REMARKS

Reconsideration of this application is requested.

Figure 3.

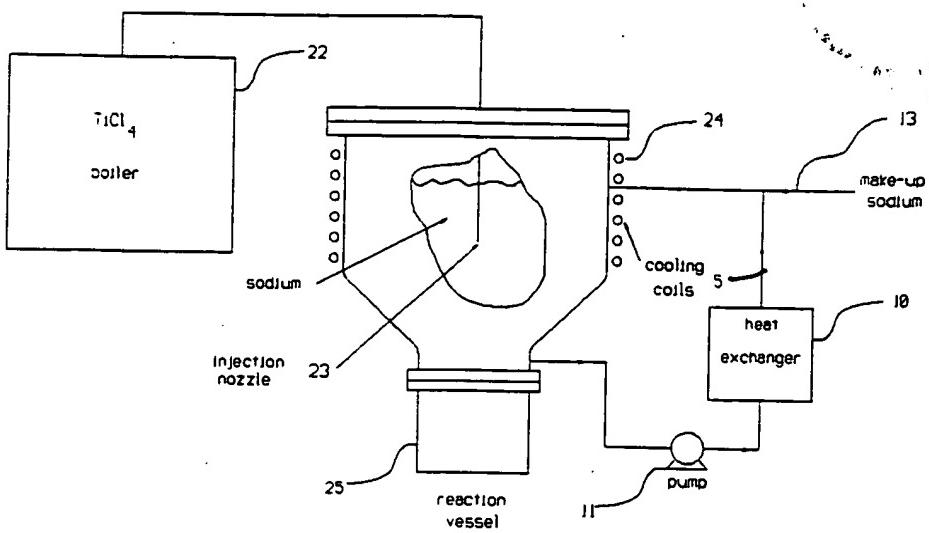
Figure 3 of the drawing was objected to because of the use of the term "injection nozzle". This term has been inserted into the specification at page 11, line 12.

Furthermore, the drawings were objected to in that the specification did not describe items 11, 19 and 21 in Fig. 1, item 5 in Fig. 3 and item 30 in Fig. 4. These matters have been attended.

All matters pertaining to the drawings have been corrected either by amendment either to the drawing, in the case of reference numeral 5 in Fig. 3 or to the specification. It is now believed that the drawings are adequately described.
